Subject: **Request for Section 404 Nationwide 33 Permit Modification and Nationwide 23 and 33 Permit Renewal** for the replacement of Bridge No. 61 on NC 197 over the North Toe River, Yancey/Mitchell Counties. Federal Aid Project No. BRSTP-197(1), WBS No. 32597.1.1, TIP Project No. B-1443.

PROJECT NO. B-1443
 MITCHELL/YANCEY COUNTY
 STATION 12+94.300 -L-
 SHEET 1 OF 5 REPLACES BRIDGE No. 61

GENERAL DRAWING
 FOR BRIDGE ON NC 197
 OVER NORTH TOE RIVER
 BETWEEN SR 1308 AND SR 1294

Permit Drawing
 Sheet 1 of 2
 7/30/2007

Permit Drawing
 Sheet 2 of 2

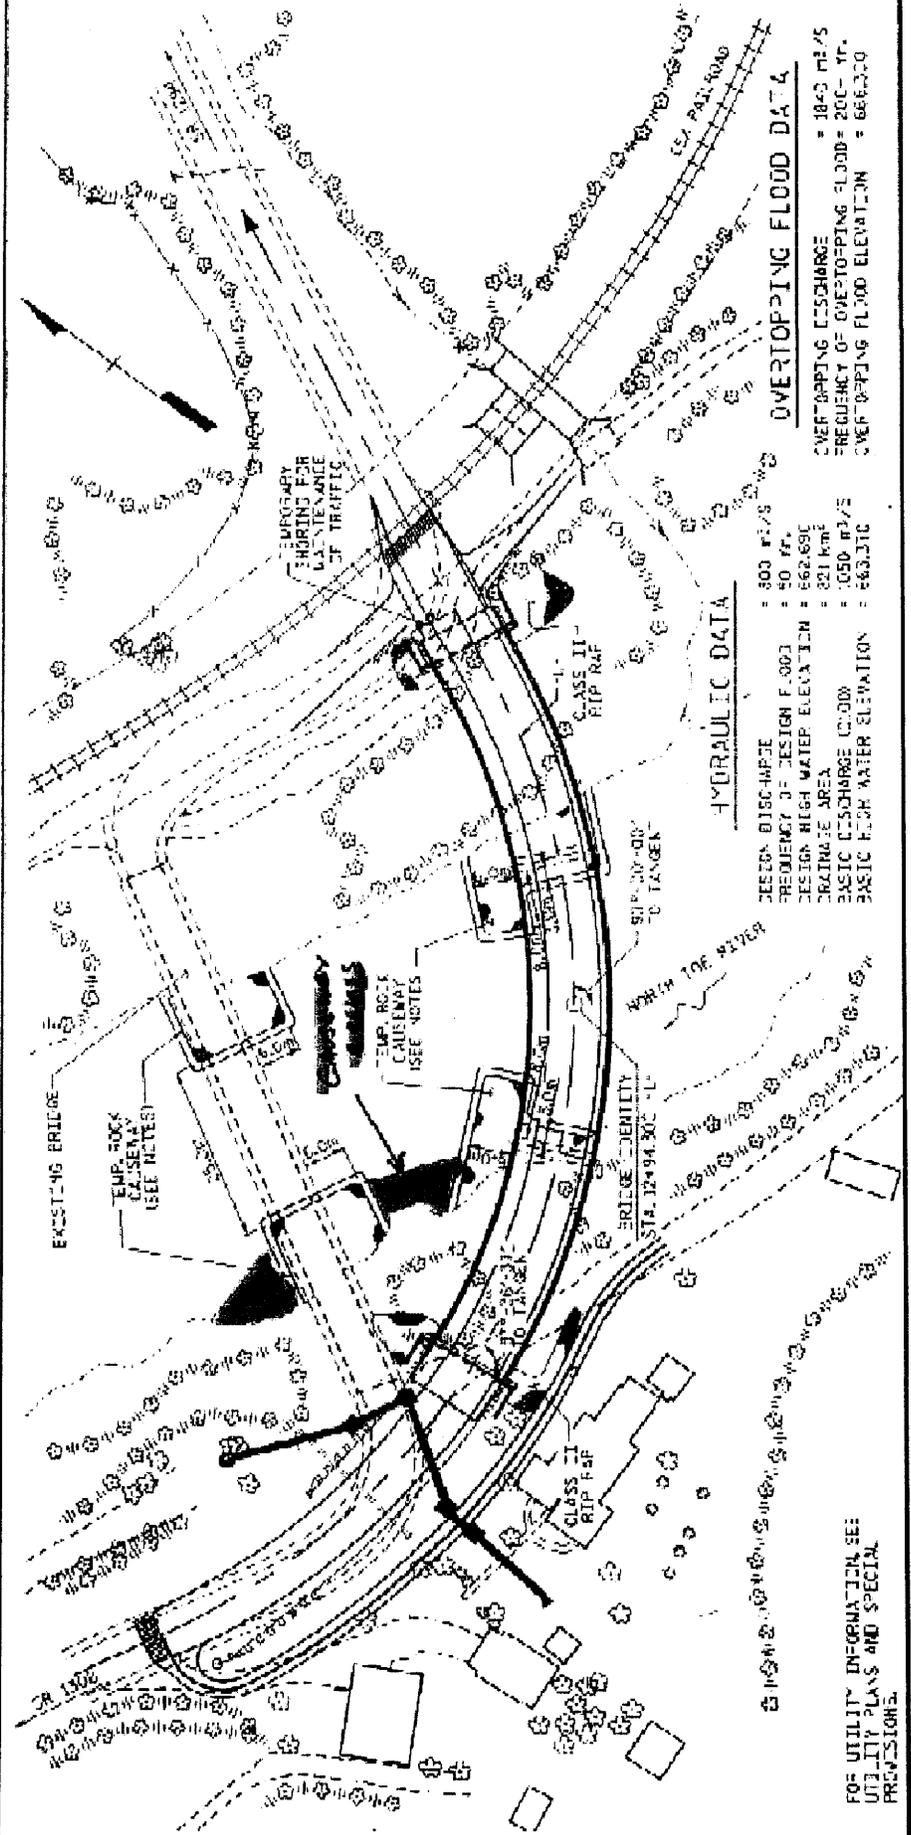
with this project, with 0.12 acre of the total due to installation of the construction causeway. It has been determined that the change to the causeways' footprints will result in a net increase of <0.01 acre of temporary impact (Sheet 1). This net increase is not significant enough to change the reportable impact quantity of 0.12 acre. As such, the total temporary impacts for the project also do not change. The placement of access roads, which are above ordinary high water, will result in no additional impacts (Sheet 2).
